Access Compliance Report

Public Rights-of-Way

(Curb Ramps)

Intersection ID: N/A	Main Street: BEREWICK_TOWN_CENTRE	Cross Street: N/A	Location: NE
ADA ID: 12A6B9C9EB40	Ramp Type: BlendTrans1	Initial Pass/Fail: Fail	Overall Compliance: No
Severity Score: 1.25			
Codes/Mitigation Info/Possible Solution		Field Measurements/Component Compliance

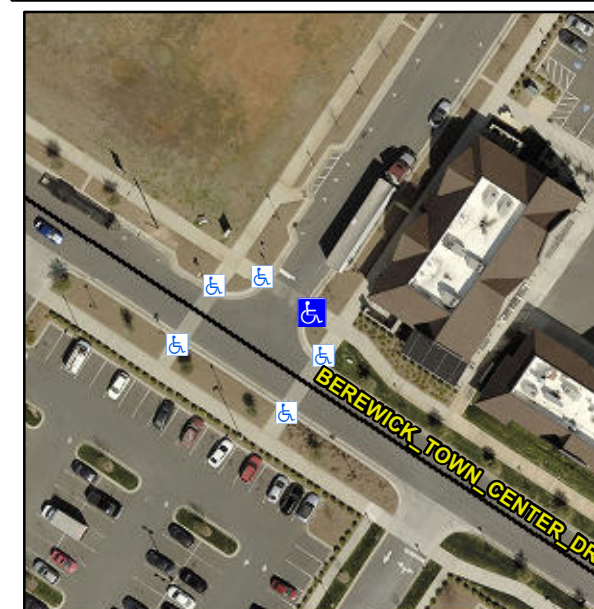
R304.5.3

Compliance	Description	Data	Compliance	Description	Data
N/A	Ramp Length (in)	180.0	Yes	BlendTrans Slope (%)	3.1
Yes	Ramp Width (in)	94.8	No	BlendTrans XSlope (%)	2.9
N/A	Flare Type LT	N/A	N/A	Flare Type RT	N/A
N/A	Flare Slope LT (%)	N/A	N/A	Flare Slope RT (%)	N/A
N/A	Flare Traversable LT?	N/A	N/A	Flare Traversable RT?	N/A
N/A	Landing Length (in)	N/A	N/A	DWS Provided?	N/A
N/A	Landing Width (in)	N/A	N/A	DWS Contrast?	N/A
N/A	Landing Slope (%)	N/A	N/A	DWS Length (in)	N/A
N/A	Landing X Slope (%)	N/A	N/A	DWS Full Width?	N/A
N/A	Landing Curb? (Y/N)	N/A	N/A	DWS Offset (in)	N/A
N/A	Shared Landing?	N/A			
N/A	Gutter Ponding?	N/A	N/A	Gutter Slope (%)	N/A
N/A	Gutter Lip Ht (in)	N/A	N/A	Gutter X Slope (%)	N/A
N/A	Painted X Walk1?	Yes	N/A	Painted X Walk2?	N/A
	X Walk 1 Direction	To NW		X Walk 2 Direction	N/A
	X Walk 1 Width (in)	97.5		X Walk 2 Width (in)	N/A
	X Walk 1 Slope (%)	0.2		X Walk 2 Slope (%)	N/A
	X Walk 1 X Slope (%)	1.2		X Walk 2 X Slope (%)	N/A

Remove & Replace Curb Ramp With Two New Directional Ramps or Equivalent.
